March 23, 2009

DOMINION NUCLEAR CONNECTICUT, INC.
MILLSTONE POWER STATION UNIT 3
RESPONSE TO REQUEST FOR ADDITIONAL INFORMATION REGARDING
A SPENT FUEL POOL CRITICALITY LICENSE AMENDMENT REQUEST

RESPONSE TO RAI QUESTIONS 21 and 24
REGARDING THE SPENT FUEL POOL CRITICALITY LICENSE AMENDMENT
REQUEST

Figure 1: Minimum Fuel Assembly Burnup and Decay Time Versus Nominal Initial Enrichment for Region 2 Storage Configuration

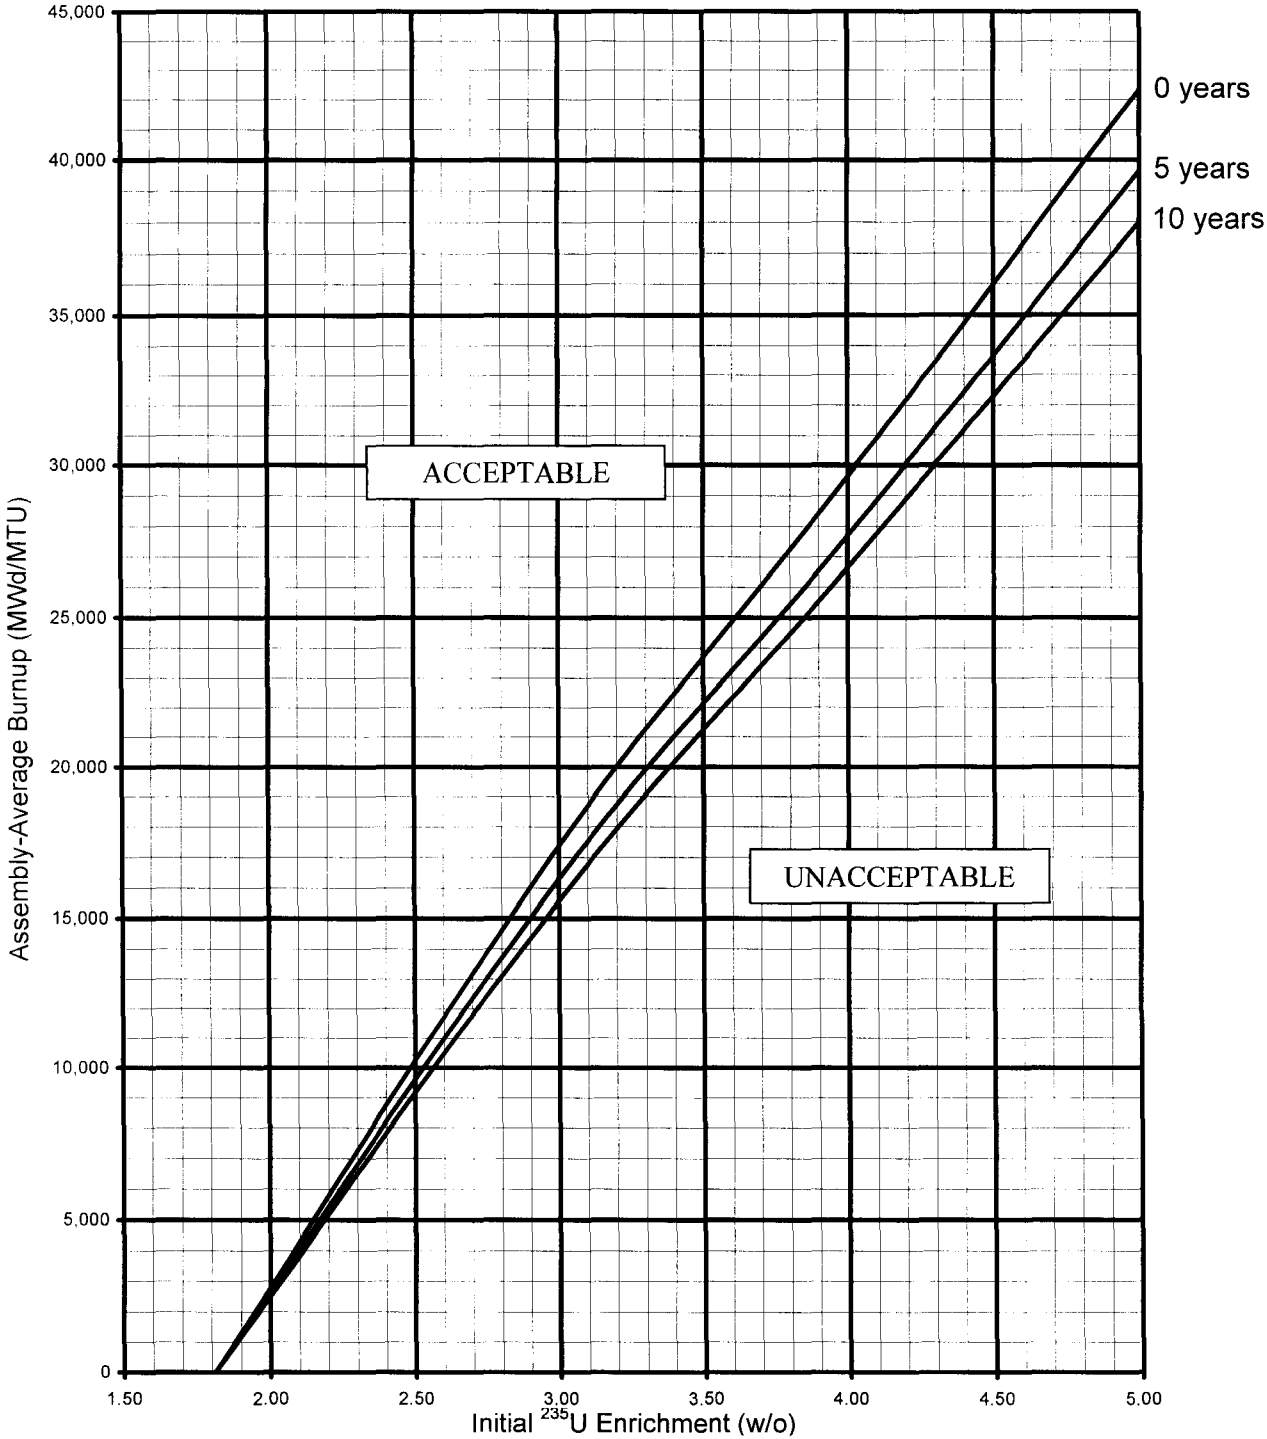
In the response to RAI 1 - 3 regarding the axial burnup distribution modeling, it is stated that Profile 5 from NUREG/CR 6801, "Recommendations for Addressing Axial Burnup in PWR Burnup Credit Analyses," March 2003, was used. In NUREG/CR-6801, Figures 3 and 7 - 18 show various profile shapes at various burnup intervals. Additionally, Figures 19 - 30 statistically demonstrate the bounding profile for various burnup intervals. Demonstrate Profile 5 is bounding for all MPS3 fuel axial burnup profiles, in particular the 15-25 gigawatt day per metric ton uranium (GWd/MTU) range.

Based on the results provided, non-conservatisms have been identified in the originally submitted WCAP curves for Region II and Region III minimum fuel burnup at various points on the curve. The proposed Region II and III burnup curves will be modified to offset the above identified non-conservatism.

Based on the results in Table 21-6, the Region II required fuel burnups at 3 w/o and 4 w/o U235 at all decay times are increased by 0.5 GWd/MTU. Based on the results in Table 21-6, the Region III required fuel burnups at 3 w/o U235 at all decay times are increased by 1.5 GWd/MTU.

The proposed revised tabular values for the Region II and Region III burnup/enrichment limits are provided in Table 21-7 (Region II) and Table 21-8 (Region III). These are plotted in Figures 1 (Region II) and 2 (Region III).

NOTE: For assemblies from Post-Uprate (3650 MWt) Cores, the nominal fuel enrichment of blankets must be ≤ 2.6 w/o U-235, and nominal blanket length must be at least 6 inches on both ends of the fuel.

Figure 3.9-3 Minimum Fuel Assembly Burnup and Decay Time Versus Nominal Initial Enrichment for Region 2 Storage Configuration

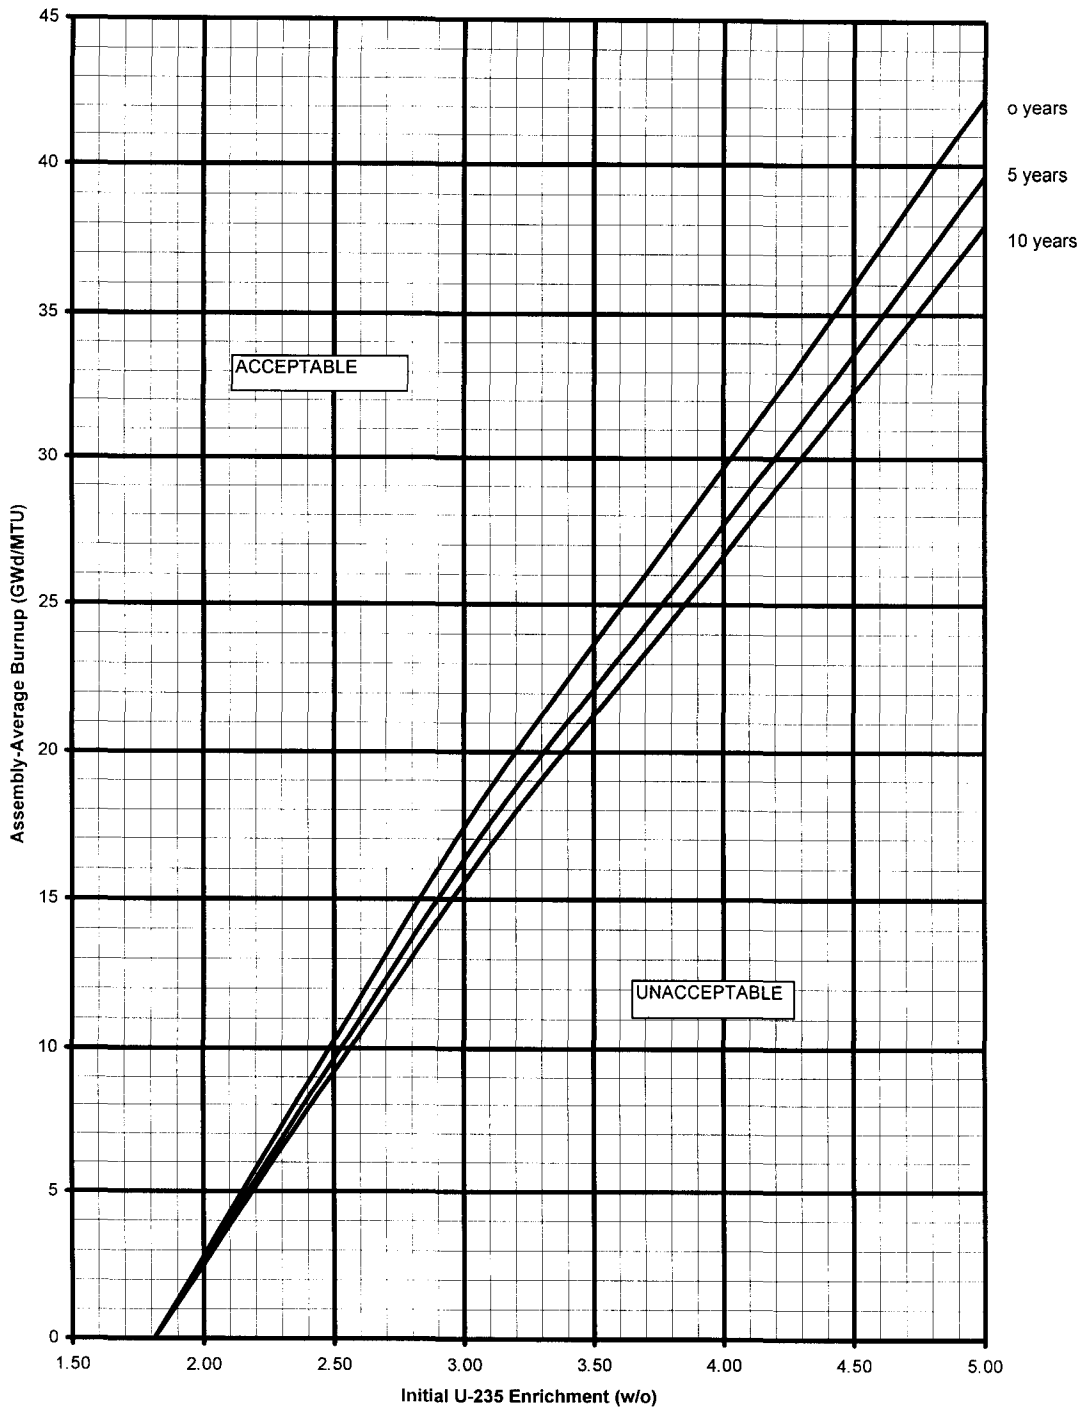
Attachment 1 contains the responses to RAI questions 21 and 24. The information in Figure 1 and Figure 2 in the response to RAI question 24 is used to update the information provided in DNC letter dated July 13, 2007 (ADAMS No. ML072000386), Attachment 3, "Mark-up of The Operating License and Technical Specifications Pages," Figure 3.9-3 and Figure 3.9-5. The updated Figure 3.9-3 and Figure 3.9-5 are provided in Attachment 2.

To implement this restriction of no future use of No Blanket fuel at MPS3, a footnote will be added to proposed Technical Specification Figure 3.9-3 for Region II fuel storage, and Figure 3-9-5 for Region III for storage of Post-Uprate fuel. Figures 1 and 2 show this footnote.

NOTE: For assemblies from Post-Uprate (3650 MWt) Cores, the nominal fuel enrichment of blankets must be ≤ 2.6 w/o U-235, and nominal blanket length must be at least 6 inches on both ends of the fuel.
